Access Compliance Report Public Rights-of-Way (Curb Ramps)

Main Street: LIVINGSTON_AVE Cross Street: BENETA_WAY Location: NE

ADA ID: RPAT211004085841 Ramp Type: Type 1 - Perpendicular Diagonal Initial Pass/Fail: Pass Overall Compliance: No Severity Score: 0

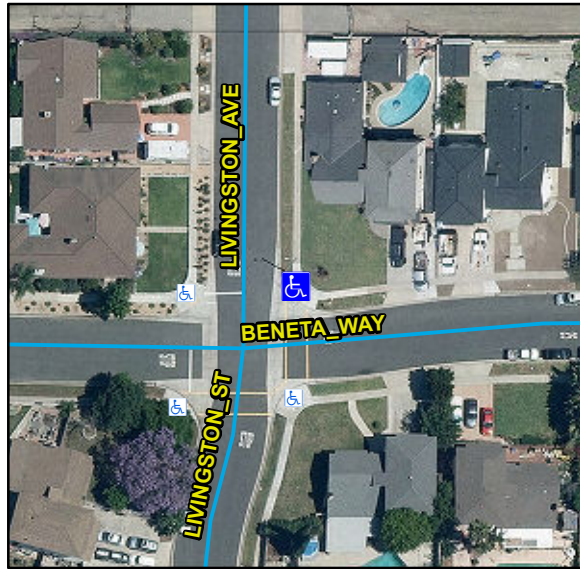
N/A	Ramp Inside Crosswalk 1	N/A	Yes	Ramp Inside Crosswalk 2	Yes
	Crossing 1 Slope (%)	4.8		Crossing 2 Slope (%)	2.2
	Crossing 1 Cross Slope (%)	1.2		Crossing 2 Cross Slope (%)	1.4
Yes	Gutter Ponding	No	No	Curb Slope	7.2
Yes	Gutter Lip Height (in)	0		Road Run Slope (%)	0.4
Yes	Gutter Run Slope (%)	2.7		Road Cross Slope (%)	1.7
Yes	Gutter Cross Slope (%)	0.5			
Yes	Overall Surface Condition: Acceptable		Yes	Perp Joint Present	Yes
	Cross Gutter Present?	Yes		Spandrel Present?	Yes
	Replace Cross Gutter?	No		Replace Spandrel?	No

Possible Solutions:

Remove & Replace Curb Slope.

R304.2.2, STD 1115
